EAST CENTRAL RAILWAY
(S&T Department)

Sub: Observation on FRS for RDPMS(Document no.RDSO/RDPMS/FRS/2024)

Observation on FRS for RDPMS (Document No. RDSO/RDPMS/FRS/24)

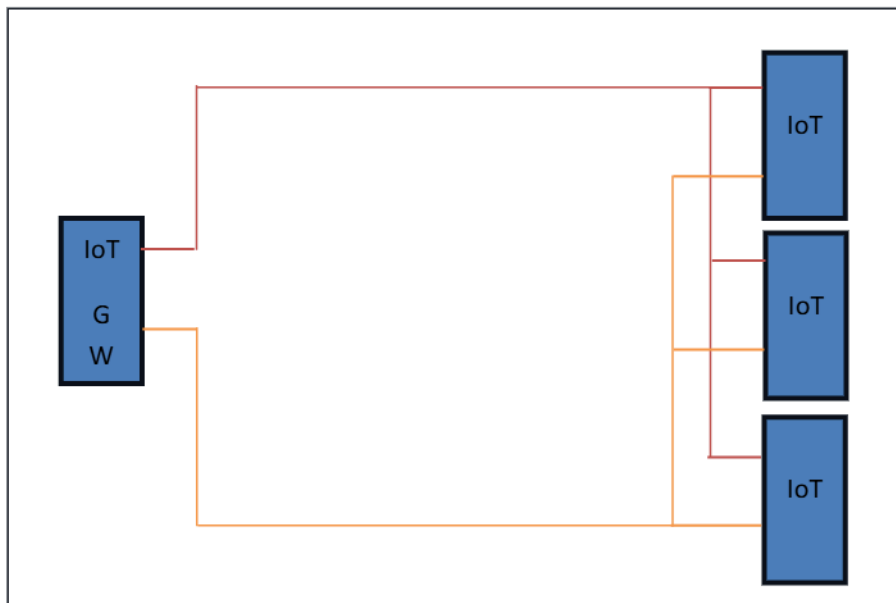
Clause No.	Observation
3.4	<p>FRS allows wired/wireless communication for connectivity between the IOTs and station gateway. However, the type of communication is not specified and no redundancy has been specified. Standardizing this will lead to ease of maintenance. It is indicated that maintenance of RDPMS will become a critical activity in near future. For commissioning the RDPMS, it is understood that different clusters of IOTs will be formed. These clusters will then be connected to the station gateway. It is suggested that the FRS specifies Optical fibre based industrial Ethernet network to connect these clusters and the station gateway. Redundancy in the form of ring can be made.</p> <p>For the communication between station gateway and CCSP, existing optical fibre or use of MPLS has been specified. For redundancy, LTE network has been considered. It is further suggested that VPN for IOTs may be setup on Railway/RailTel network MPLS infrastructure. For the purpose of redundancy, the industrial 4G LTE router that is proposed to be used in the LTE work be specified to create better market and allow the advantage of economy of scale for the manufacturer of the LTE router in support of Make-In-India initiative of the Government. The architecture diagram proposed is as under:</p> <div data-bbox="347 1039 1407 1697"> <pre> graph TD Internet((Internet)) --- Firewall[Firewall] Firewall --- CCSP[CCSP] Firewall --- IoTVPN((IoT VPN)) IoTVPN --- AppServers[Application Servers] IoTVPN --- LTERouter[LTERouter] LTERouter --- STNGW((STNG W)) </pre> </div> <ul style="list-style-type: none"> • Redundancy for LTE router is not proposed as the data is not considered critical in nature and STNGW can store data locally as per clause 6.5. • Redundancy for STNGW is not considered as the data is stored in IoT for 10days as per clause 4.2.2 • LTE router to have the same specs as defined in the LTE work for reasons explained above.

- Industrial Ethernet switches with 4 SFP cage and one RJ-45 port preferred.
- All gigabit Ethernet
- DIN Rail mount switches.
- Using this architecture will enable Railways to setup a high speed LAN/WAN in the station. Using appropriate protocol like OpenSafety etc., this network can be used in future for exchange of signaling information. It will also bring in standardization of communication in the station yard.

<ul style="list-style-type: none"> Defining standard Modbus RTU protocol for communication between IoTGW and IoT will standardize this and enable interoperability. Redundancy can be achieved in this communication by utilizing two RS485 ports at each IoT and IoTGW deciding which one to use.
